GM & O SUBDIVISION

APPLICATION NUMBER 7 DATE September 20, 2018

APPLICANT GM & O Subdivision

REQUEST Subdivision

DETAIL SITE PLAN

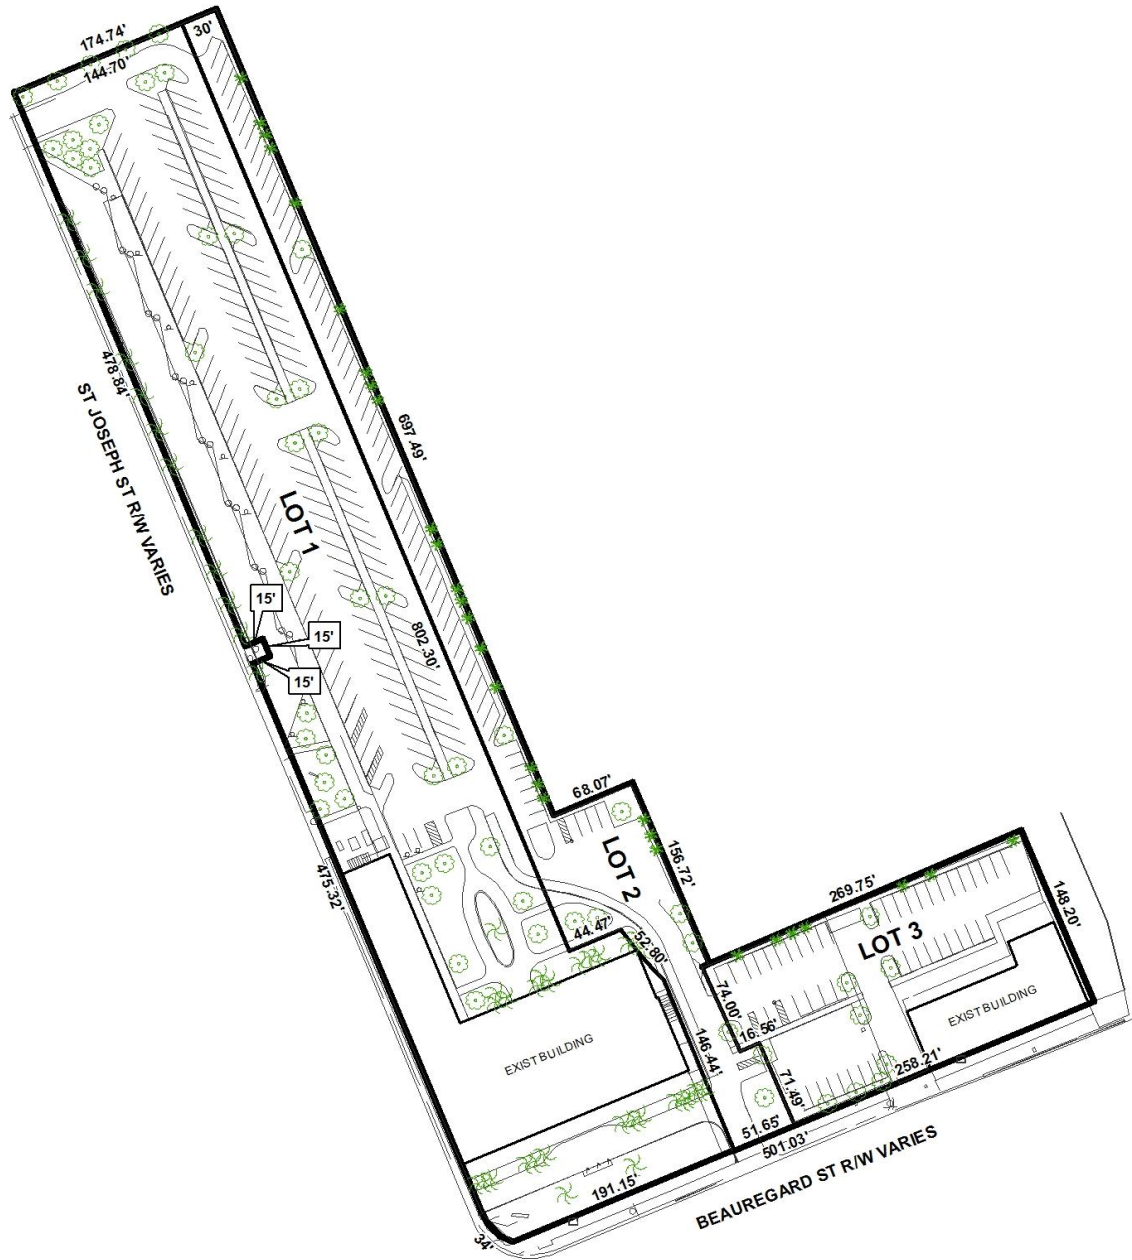
The lot sizes are not labeled in square feet and acres. The plat should be revised to depict the lot sizes in both square feet and acres, or provide a chart furnishing the same information. Although the lots are not labeled, it does appear that the proposed lots, with the exception of Lot 2, will meet the minimum size and frontage requirements as regulated by Section V.D.2. of the Subdivision Regulations. While Lot 2 complies with minimum area requirements, it would be less than 60' wide at the building setback line. It should be pointed out that Lots 1 and 2 do not comply with Section V.D.3. of the Subdivision Regulations regarding the maximum width to depth ratio. Thus, a waiver of both Sections V.D.2. and V.D.3 of the Subdivision Regulations will be required.

The site has frontage along Beauregard Street, a minor street with curb and gutter, thus requiring 50' right-of-way. It appears that there is sufficient right-of-way, thus no dedication will be required; however the plat should be revised to depict a minimum right-of-way of 50', instead of illustrating a variable. The site also has frontage along Telegraph Road/ North Conception Street Road, a major street with an 80' right-of-way. The plat should be revised to change the labeling of the road from St. Joseph Street to Telegraph Road/ North Conception Street Road and change the right-of-way width from "varies" to depict a minimum right-of-way width of 80 feet.

The overall site is currently developed with two existing curb-cuts to Beauregard Street (Lots 2 and 3 each have one curb-cut), and one existing curb-cut to Telegraph Road/ North Conception Street Road (Lot 1). As a means of access management, Lots 2 and 3 should be limited to one curb-cut each to Beauregard Street, and Lot 1 should be limited to one curb-cut to Telegraph Road/ North Conception Street Road, with the size, location and design to be approved by Traffic Engineering, and ALDOT, and conform to AASHTO standards.

Section V.D.9. of the Subdivision Regulations requires the provision of a 25' minimum building setback from the "front property line". The preliminary plat does not depict the 25' minimum building setback lines. If approved, the 25' minimum building setback lines along both Beauregard Street and Telegraph Road/ North Conception Street Road should be depicted on the Final Plat.

- 1) revision of the plat to depict the 25' minimum building setback lines along both Beauregard Street and Telegraph Road/ North Conception Street Road should be depicted on the Final Plat;
- 2) revision of the plat to depict the right-of-way width along Beauregard Street;
- 3) revision of the plat to change the labeling of the street from St. Joseph Street to Telegraph Road/ North Conception Street Road;
- 4) revision of the plat to depict the right-of-way width along Telegraph Road/ North Conception Street Road;

- 5) revision of the plat to depict the lot sizes in square feet and acres;
- 6) placement of a note on the Final Plat stating Lots 2 and 3 should be limited to one curb-cut each to Beauregard Street, and Lot 1 should be limited to one curb-cut to Telegraph Road/ North Conception Street Road, with the size, location and design to be approved by Traffic Engineering, and conform to AASHTO standards;
